H. B. ROBINSON STEAM ELECTRIC PLANT, UNIT NO. 2
DOCKET NO. 50-261/LICENSE NO. DPR-23

SUPPLEMENT 1 TO TECHNICAL SPECIFICATIONS
CHANGE REQUEST FOR ULTIMATE HEAT SINK (UHS)

CLARIFICATIONS TO THE
TECHNICAL SPECIFICATION CHANGE REQUEST FOR
ULTIMATE HEAT SINK

Figure 1

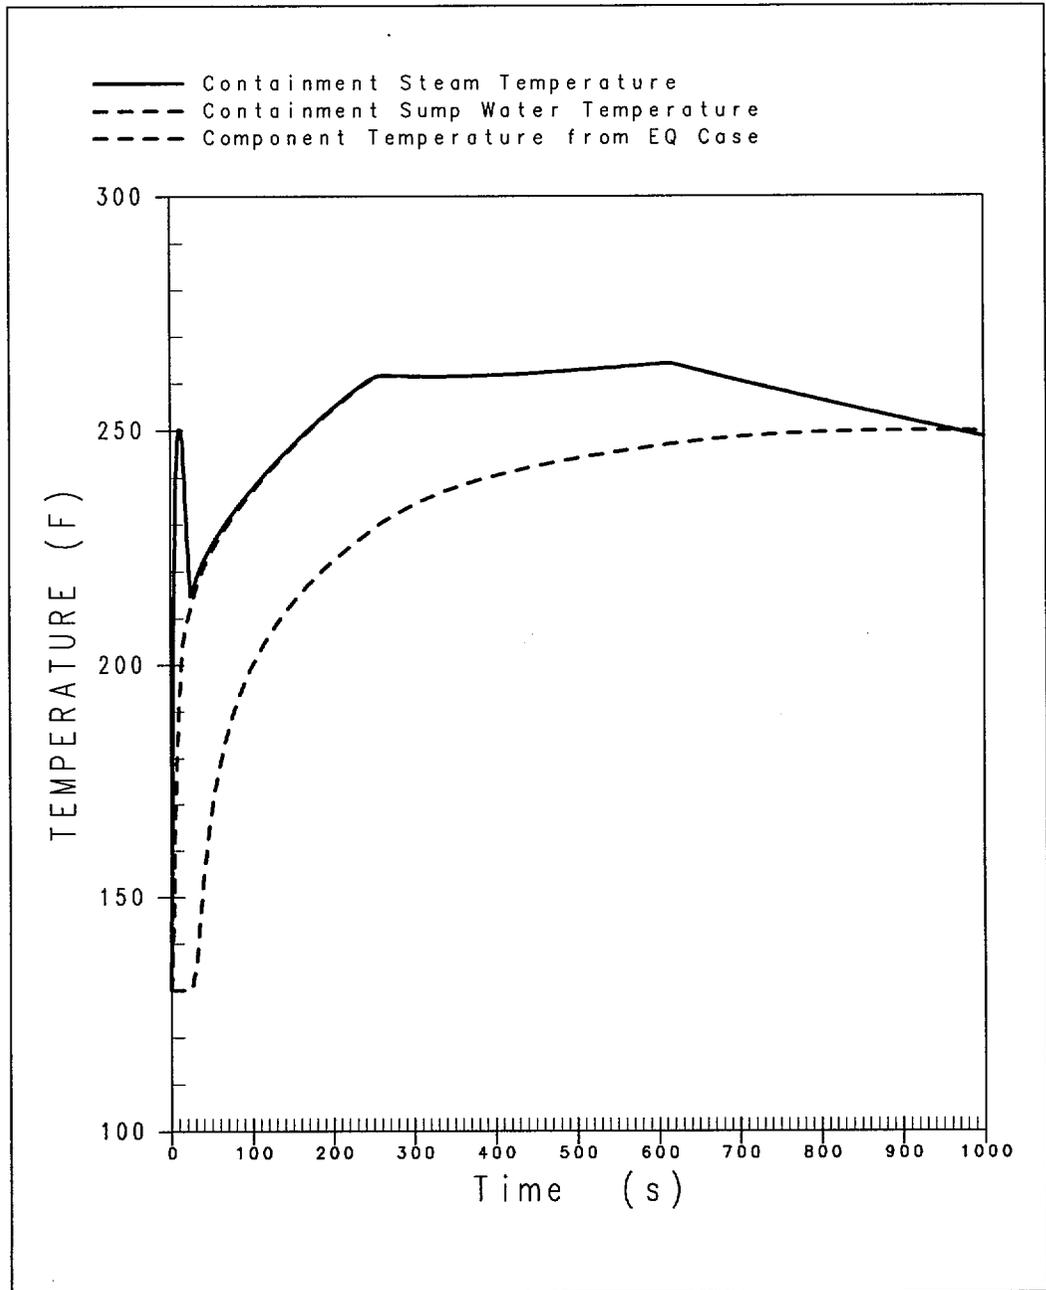
- a. The MSLB analysis result shows an early peak containment temperature as a result of superheat. This temperature is less than 280°F, the qualification temperature.

Consequently, no thermal analyses were required to qualify components to temperatures higher than the manufacturer's peak qualification temperature. The MSLB component temperature curve is included as Figure 1.

It should be noted that the UFSAR currently has a component qualification temperature of 263°F. In the current MSLB analysis there is a short temperature peak of 350°F. However, because of the short duration of the temperature peak, the surface temperature of components has been determined to not be impacted beyond the current qualification limit.
